PD Modification Application: PRS 22-0022

BOCC Land Use Meeting Date: December 14, 2021

Development Services Department

The applicant requests a modification to allow for an additional right in/out driveway connection to US 301, for access to Parcel "F" north of Paseo Al Mar Boulevard. PD 04-0558, as most recently modified by PRS 15-1152, was approved in 2015 to allow for a maximum of 2,260 dwelling units and a mixture of commercial and cultural/institutional uses. Specifically, 1,600 single-family conventional detached dwelling units, 600 townhouses (apartments and single-family attached options), 150,000-square foot shopping center (commercial, neighborhood (CN) uses permitted) including a maximum 80,000-square foot mini warehouse facility, child care center (300 children), public school, county park and pocket parks, pedestrian trail, and community center.

2.4 Proposed Site Plan (partial provided below for size and orientation purposes. See Section 8.2 for full site plan)

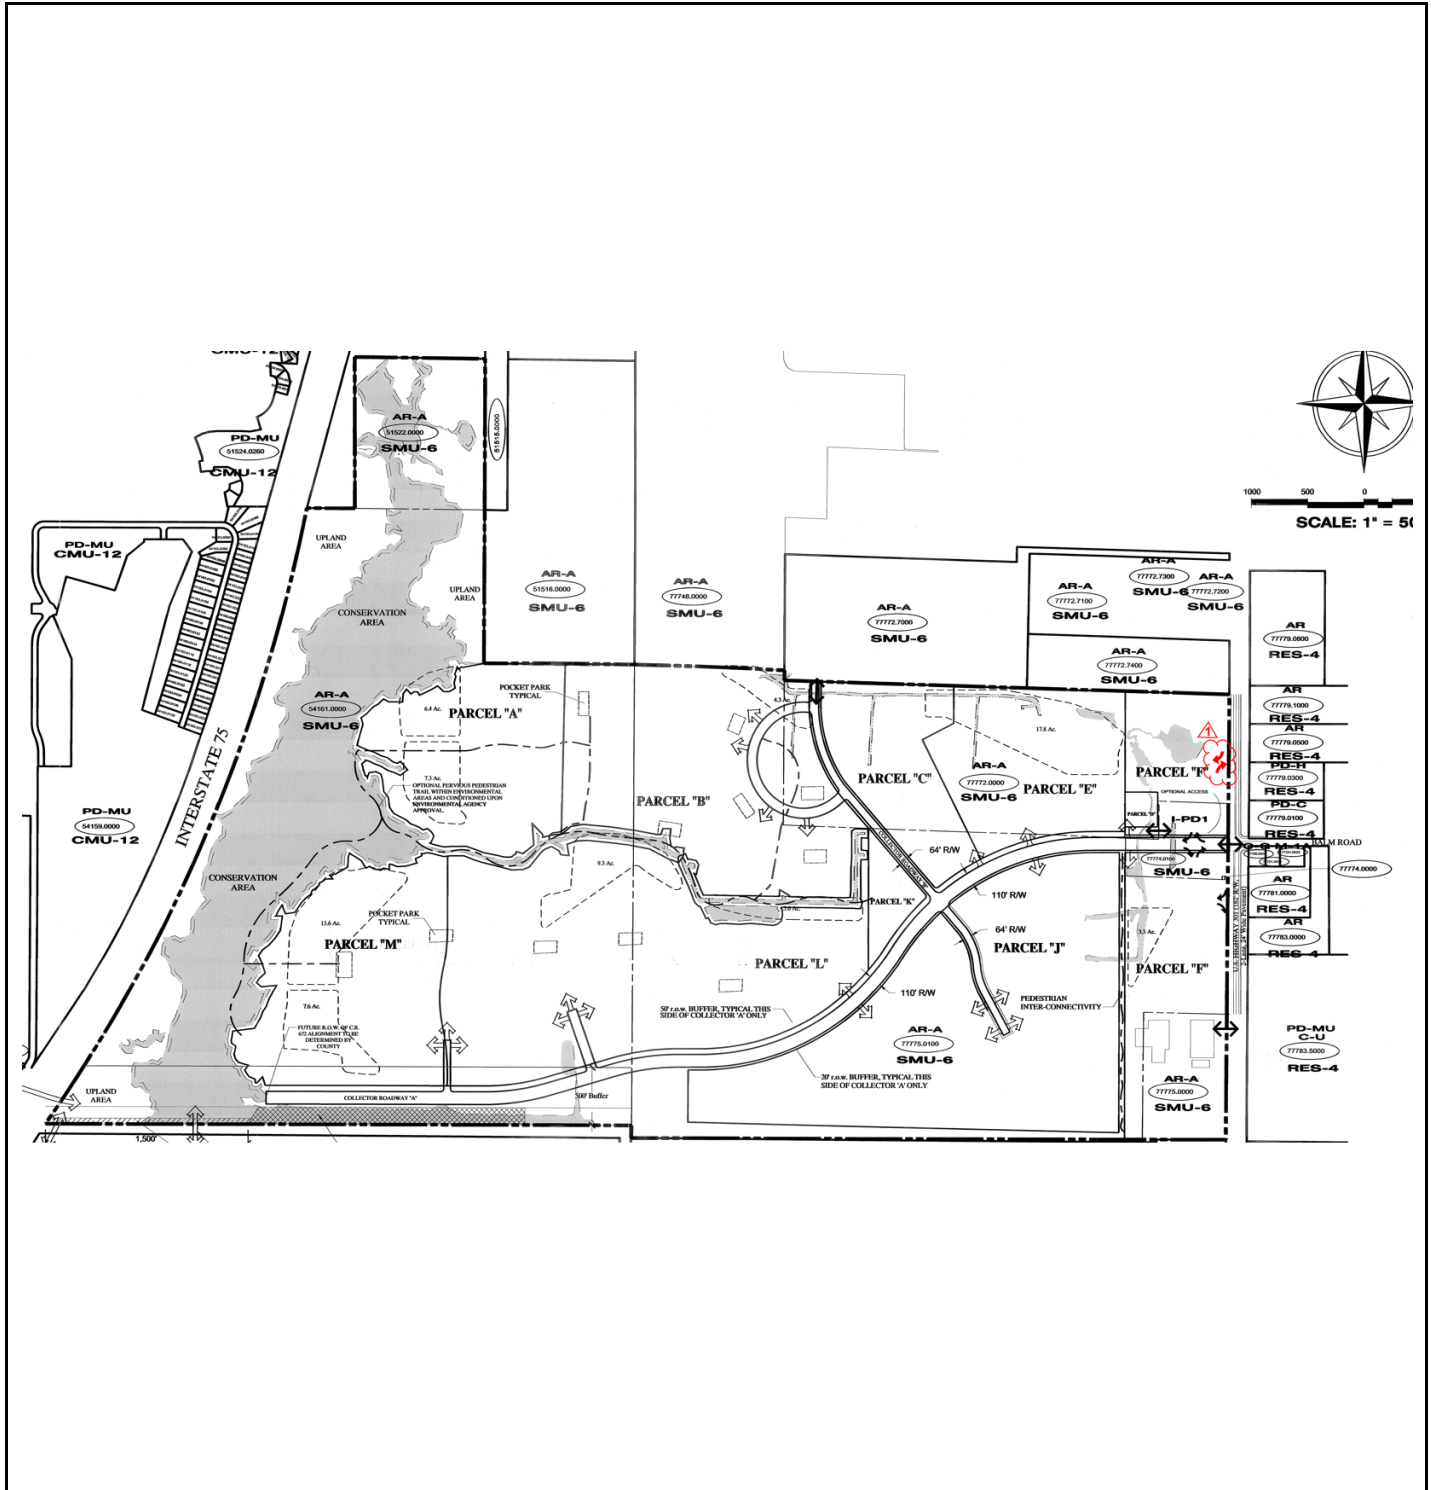
Existing Approval(s):	Proposed Modification(s):
<p>Approved condition 24. States: The Developer shall be restricted to two direct access points onto US 301, not including CR 672 (Balm Rd). The FDOT shall determine the type of access to be provided. The FDOT may restrict or prohibit an access to US 301 that does not conform to its access management regulations.</p>	<p>The Developer shall be restricted to two<u>three</u> direct access points onto US 301, not including CR 672 (Balm Rd). The FDOT shall determine the type of access to be provided. The FDOT may restrict or prohibit an access to US 301 that does not conform to its access management regulations.</p>
<p>The approved general site development plan demonstrates two access points onto US 301. Specifically, one right in / right out egress and ingress access point and one vehicular egress and ingress access point onto US 301.</p>	<p>The proposed general site development plan demonstrates an additional right in / right out egress and ingress access point onto US 301.</p>

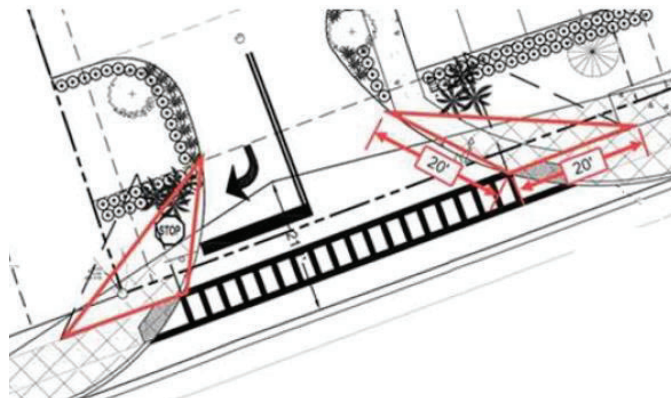
16. Maintain 20' pedestrian sight triangles and draw the triangles on the plans to show there are no obstructions taller than 24" within the triangles. (See example below)

Driveways leading onto state roads need to have min. 20' x 20' clear 'pedestrian sight triangles' on each side of the driveway, at the edge of the sidewalk. It should be measured as 20' up the sidewalk and 20' up the driveway from the point at which the sidewalk meets the driveway. Nothing above 2' in height from the pavement elevation (except for the stop sign post) should be placed in these triangles. Also, no parking spaces should be in these triangles, not even partially. Please draw in and label these 'pedestrian sight triangles' on the plans. Here is an example of what these triangles look like and how they are positioned (see red triangles in the attached example)
